From: Southern Water Planning <SouthernWaterPlanning@southernwater.co.uk>
Sent: 15 June 2023 13:45
To: Planning
Subject: DC/23/0189: - Sandgate Nursery West End Lane, Henfield, West Sussex BN5 9RD.
Attachments: DSA000023401.pdf; GIS.pdf; Growth Build Info Request Letter BAU.docx

Our ref
DSA000023401

Proposal: Outline application for erection of a continuing care retirement community of up to 72 units of accommodation (Use Class C2) and up to 10 starter homes (Use Class C3) with associated community facilities including medical centre and on-site laundry and catering facilities, with access, infrastructure, open space, landscaping and associated works (all matters reserved except for access).

Site: DC/23/0189: - Sandgate Nursery West End Lane, Henfield, West Sussex BN5 9RD.

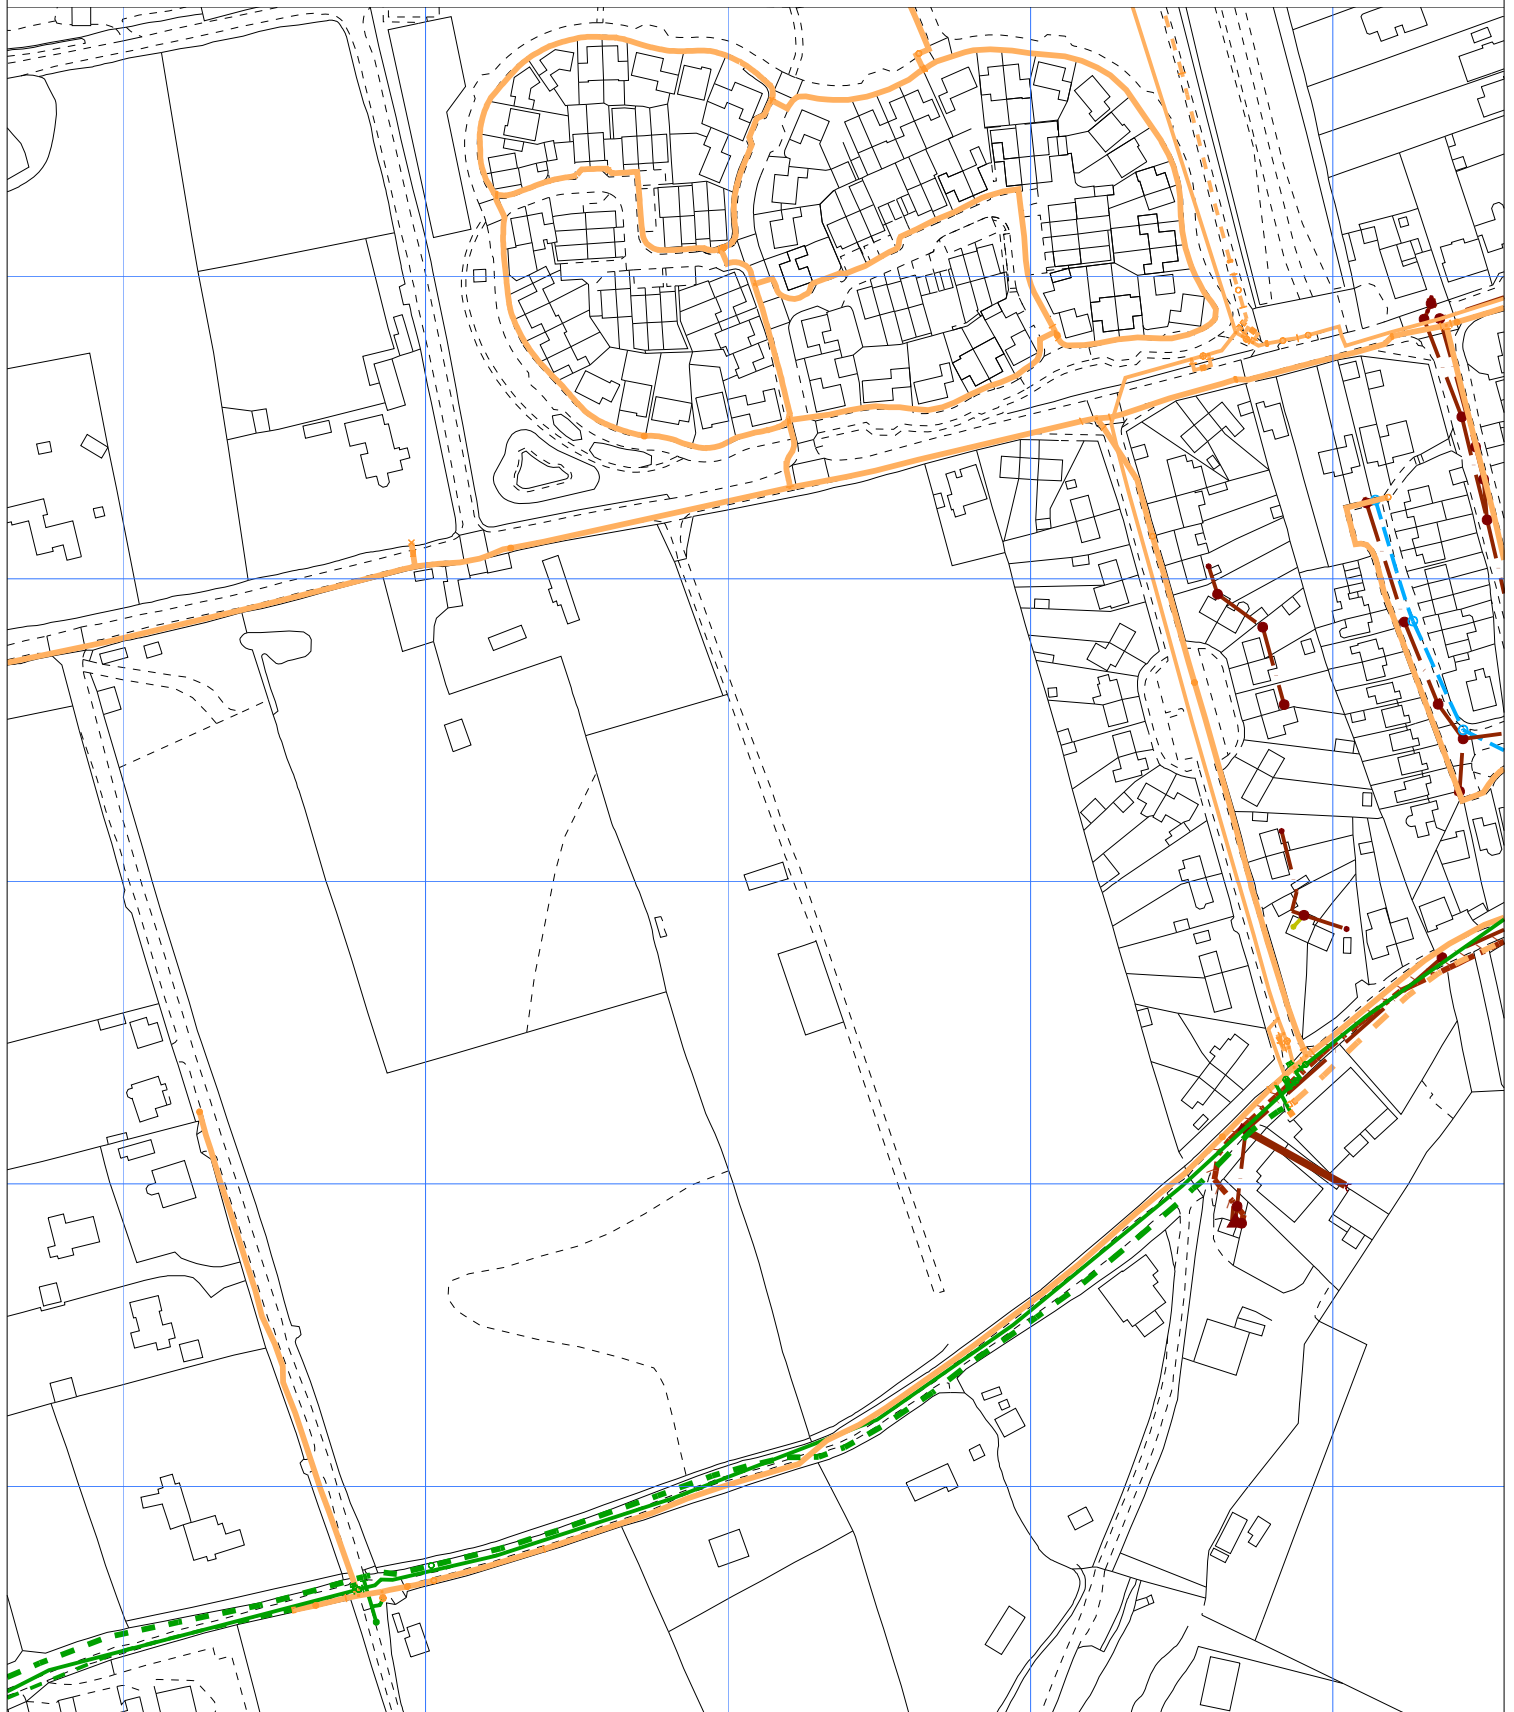
Please see the attached extract from Southern Water records showing the approximate position of water distribution mains within the access of the development site. The exact position of the public assets must be determined on site by the applicant in consultation with Southern Water, before the layout of the proposed development is finalised.

- The 4 inches water distribution main requires a clearance of 6 metres on either side of the water distribution mains to protect it from construction works and to allow for future access for maintenance.
- No excavation, mounding or tree planting should be carried out within 6 metres of the external edge of the public water distribution mains without consent from Southern Water.
- No new soakaways, swales, ponds, watercourses or any other surface water retaining or conveying features should be located within 5 metres of a public water distribution mains.
- All existing infrastructure, including protective coatings and cathodic protection, should be protected during the course of construction works.
